elm creek Watershed Management Commission

AGENDA June 14, 2017

<u>Laurel Creek</u> <u>Rogers, Project #2017-014</u>

<u>Hindu Society-Staff Housing (revised plans)</u> <u>Maple Grove, Project #2017-021</u>

Three alternative trail alignments were explored in addition to the proposed trail (see attached Cartway Road Trail Project figure).

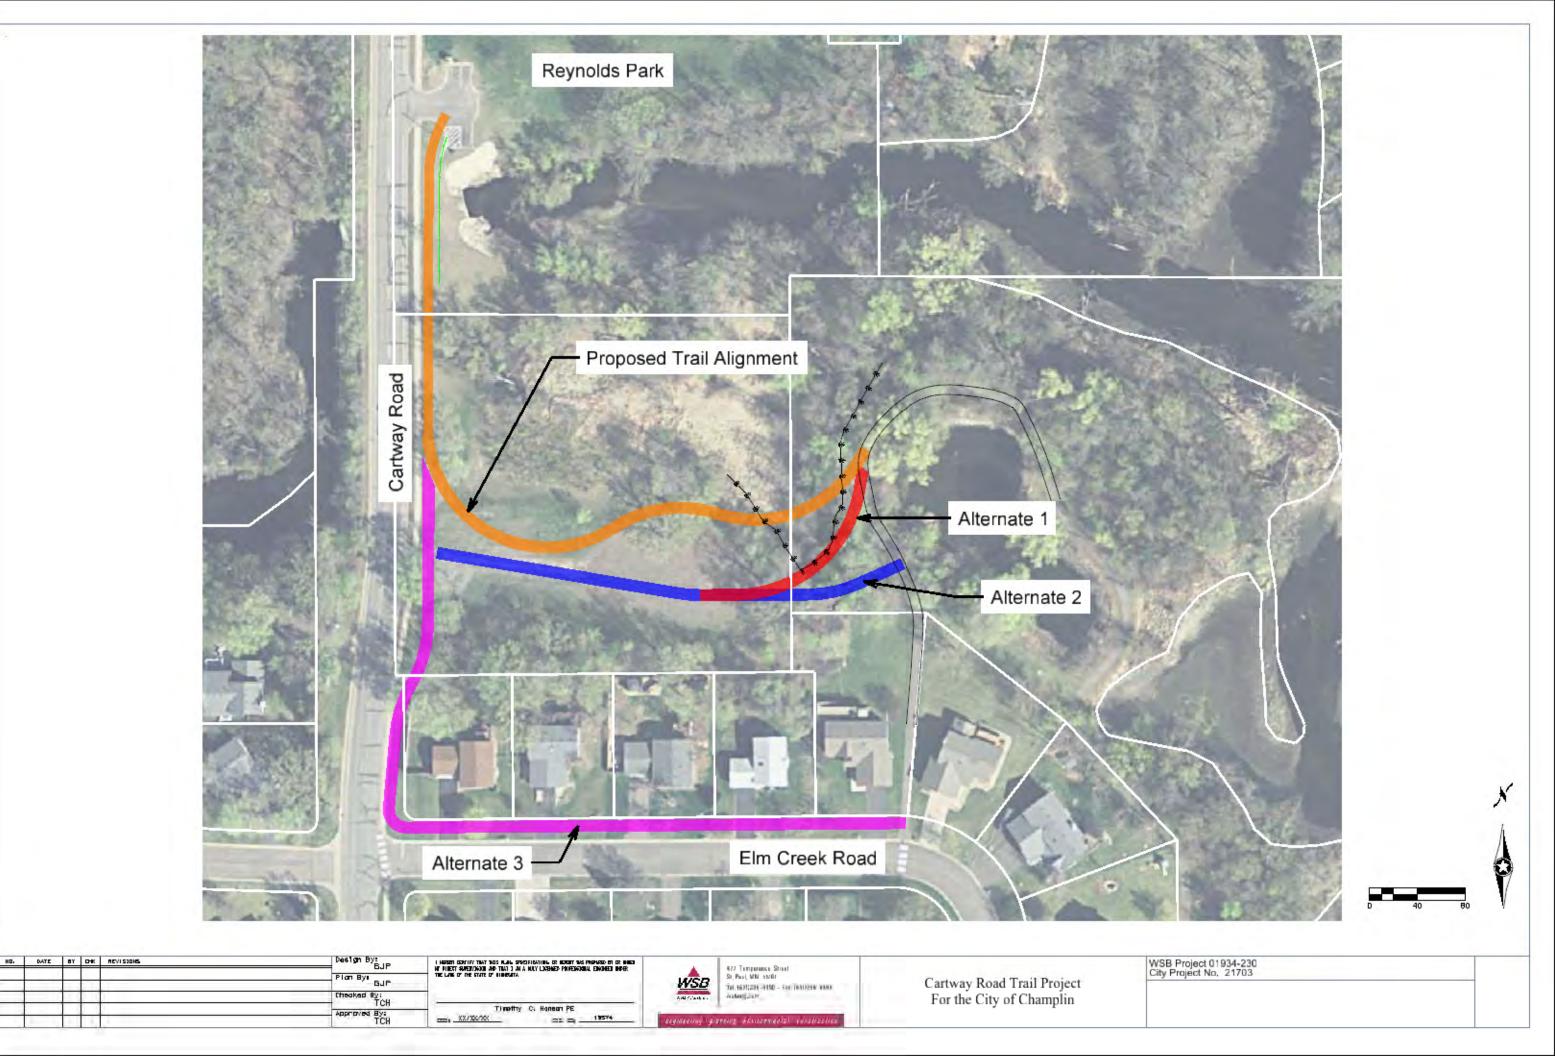
- 1) Can you provide at least two alternative alignments of the trail that show why or why not they meet the bike design standards or the trees and wetland areas they will impact. Preferred vs alternatives.
 - a. A specific tree survey isn't necessary, but the diameter and type that would be impacted by the alternatives would be helpful.

Preferred alternative: The proposed trail alignment goes south along Cartway Road and then turns east to connect with the existing trail within the area. The proposed trail alignment was selected as it maintains a greenway feel to the trail, meets trail design standards for a continuous trail, and has balanced impact on the environment and on the adjacent neighborhood. The alignment has a proposed wetland impact of 2,172 square feet and has the least impact to trees (10 trees, 8 inches dbh or less, ash and boxelder) and grading disturbance.

Alternative 1: This alternative has the trail alignment shifted further south than the preferred trail alignment. This alignment would still have wetland impact due to grading on the north side of the trail to provide the necessary clear zones for the trail. The slopes adjacent to the wetland area are steeper and slightly higher along this alignment, which would result in longer slopes extended on the north side of the alignment into the wetland area. This would cause more tree removal than the preferred alternative (24 ash trees ranging from 8 – 14 inches in Diameter) and slope grading along with approximately 1000 square feet of wetland impacts. The amount of tree impact and grading along with the wetland impacts has made this alignment undesirable.

Alternative 2: This alternative follows alternative 1 alignment and then stays further south to meet up with the existing trail. This trail alignment does not create the continuous route as desired by the City, as this alignment ties into the existing trail at a 90-degree angle. This is not conducive to bikers using the path and creates a safety concern for the city as it limits sight lines of the approaching trail. This alignment would have greater tree impacts than the preferred alternative (14 trees 8-12 inches dbh, ash, box elder, and elm) and along with approximately 100 square feet wetland impacts due to the necessary slopes that are required for the trail and clear zones. Because the lack of continuity and poor sight lines create safety risks for bikers, the tree removal is greater, and wetland impacts are not avoidable, this trail alignment was deemed undesirable.

Alternative 3: A third alternative was explored to extend the trail along the north side of the local residential street of Elm Creek Road. Constructing the 10-foot trail within a 14-foot space that crosses five driveways is very undesirable. Due to mailboxes and street signs, trail easements would be required from the adjacent properties. The north- south trail extension adjacent to Cartway Road would also require trail easements, tree clearing and impacts on private property. A significant deterrent for this alignment is the trail would no longer be adjacent to Elm Creek and it would lose its greenway appeal.

Based on the above analysis it was determined that the proposed trail creates the desired greenway appeal the City desires for the trail.

ABSTRACTION CREDIT AREAS

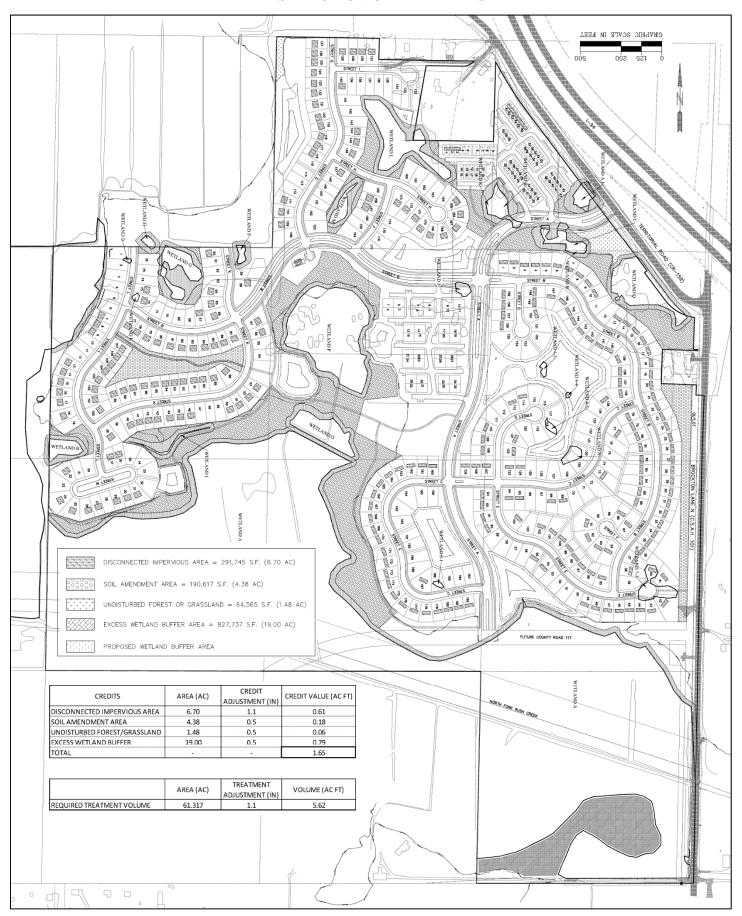
- 22) The abstraction requirement for 61.32 acres of new impervious cover is 5.62 acre-feet. The project is proposing to use stormwater reuse for irrigation, upland preservation, wetland buffer oversizing, soil amendment and impervious area disconnection to achieve the abstraction requirement. In addition to these measures, four of the basins will have biofiltration benches. Following table is a summary of the abstraction credits claimed by this project. Volume abstraction plan meets the Commission's standards.

GRADING PLAN

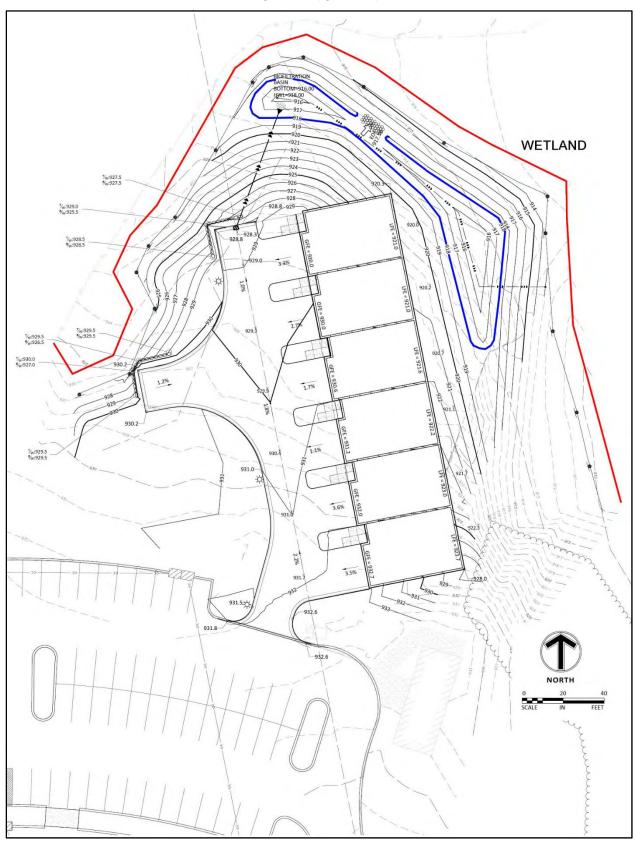
- 9) <u>Rule F.</u> Floodplain Alteration. The site is at the confluence of North Fork and South Fork Rush Creeks. The base flood elevation at this site is established at 912.30 feet (NGVD 1929 datum). The proposed revised grading shows no impact to the floodplain.

- 11) <u>Rule I.</u> Buffer requirements. At the time of this report, wetland buffer widths were not in compliance with the Commission's rules. This was conveyed to the applicant's engineer on June 13. Staff was informed that the plans were being revised.

GRADING PLAN

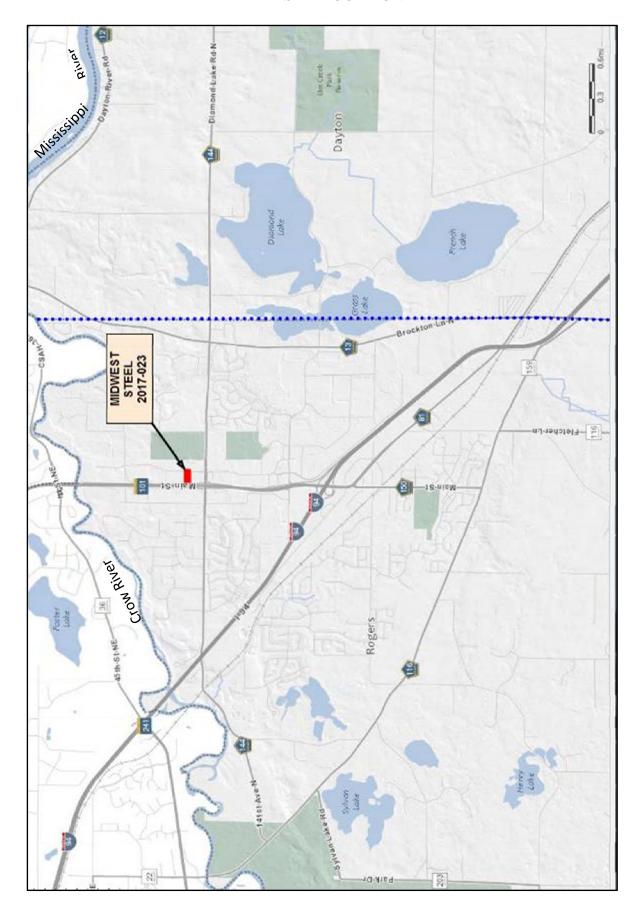
- 6) The storm sewer outlets draining the parking lots (north and south lines, not the roof drains) require pre-treatment. Pretreatment basins or hydrodynamic separator sump manholes would be required for the north and south sewer lines. Please incorporate details for pre-treatment of these two storm sewer lines.

- 7) The inverts of the storm inlets into the infiltration pond must be at the bottom of the pond (890.0 892.0) with significant riprap protection. Due to the expected rapid infiltration, the pond is expected to be empty when a storm comes. The proposed FES inverts will have 5-7 feet of drop to the bottom of the pond, and likely will cause erosion. Please revise the pipe inlets.
